# TOWN OF GUILDERLAND

## MEMORANDUM

SUBJ: Site Plan Review Associated with a Special Use Permit – Costco Retail Facility  
Crossgates Releaseco, LLC

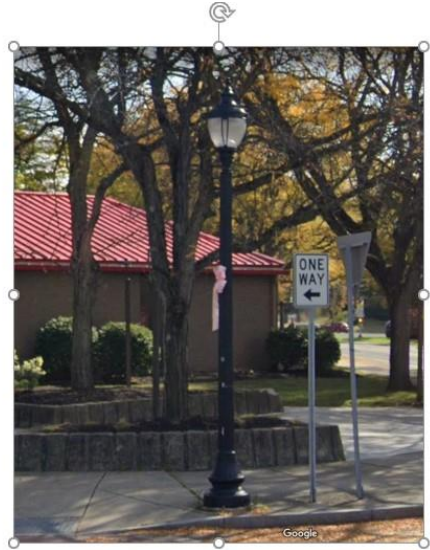
1. The landscape plan should be revised to incorporate comments from Neil Gifford, Conservation Director with the Pine Bush Preserve Commission in an email dated March 16, 2023. The proposed white pine and white spruce should be replaced with pitch pine.
2. The Westmere Corridor Study recommended street trees to be installed abutting Western Ave on the SW corner (see image below) of the proposed Costco site. The proposed landscape plan (see image below) should be revised to include additional street trees in this location. The Planning Board may also want to consider requiring a small pocket park/seating area in this location.

- The off-site improvement plans should be revised to include pedestrian scale lighting along the proposed multi-use trails. The plans should include the heights of the poles and spacing between each pole. A few examples of light poles appropriate for use along the multi-use trail are shown in the images below.

**Proposed Location – Costco Offsite Greenspace Plan**

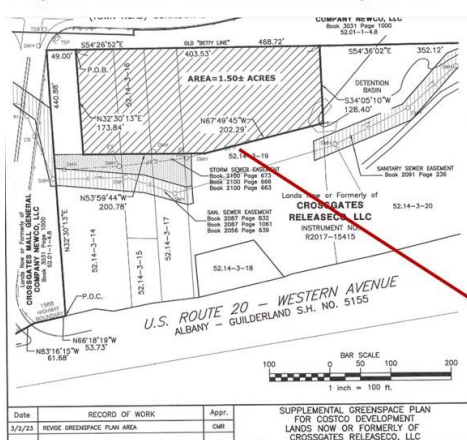
- The Site Details Plan (Sheet 16) shows a galvanized steel chain link fence is proposed to be installed between the multi-use trail and retaining walls. The Planning Board should consider a more decorative style of fencing to be installed in these areas.
- The Planning Board may want to consider whether the proposed 1.5 acre off-site greenspace area should be developed as a low impact pocket park. The greenspace area is located near the Tru by Hilton hotel, 24-unit apartment building currently under construction and main CDTA bus stop for Crossgates Mall. Additionally, the proposed greenspace is located in an area identified in the Westmere Corridor Study for future bicycle and pedestrian links (see images below). An email was sent to the Town Parks and Recreation Director seeking input on the proposed greenspace area.
